Scotts Millpond Dam (Inventory Number VA 05706 Rappahannock River Basin.
Essex County, Commonwealth of Virginia.
Phase I Inspection Report.

PHASE I INSPECTION REPORT
NATIONAL DAM SAFETY PROGRAM

NAME OF DAM: SCOTTS MILLPOND DAM

PHOTO 1. Principal Spillway Inlet, Right Embankment in Background

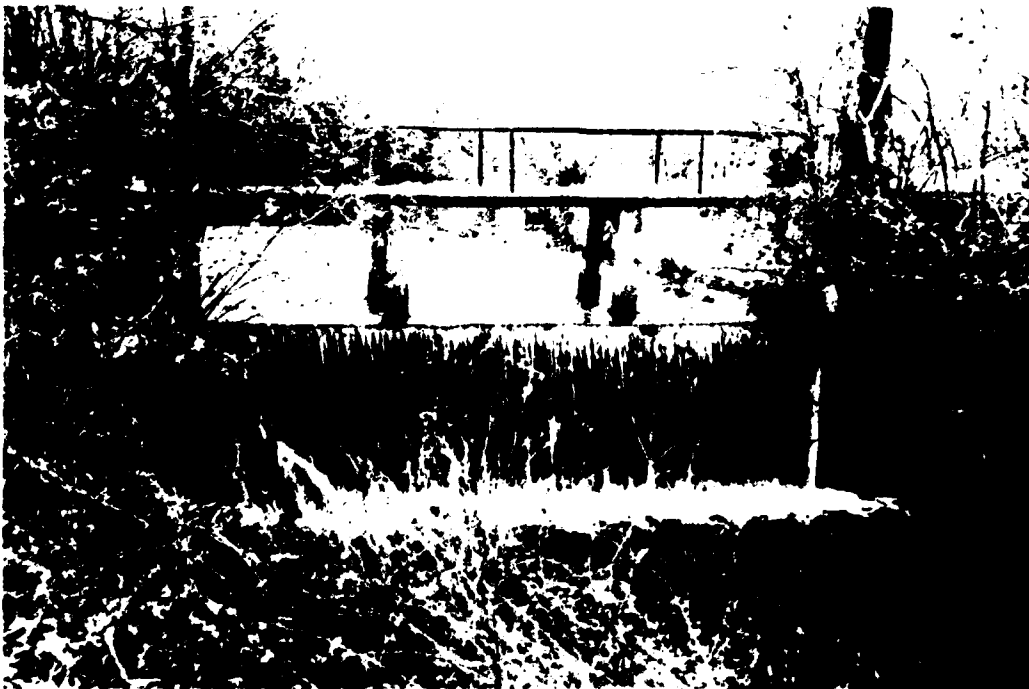
- 3 1 3 Appurtenant Structures: The principal spillway, as described in Section 1.2.1, is in good condition with no spalling or cracking in the concrete bottom and concrete and brick sides. There is a footbridge that crosses the spillway that has 4 concrete piers. The footbridge is in good condition.
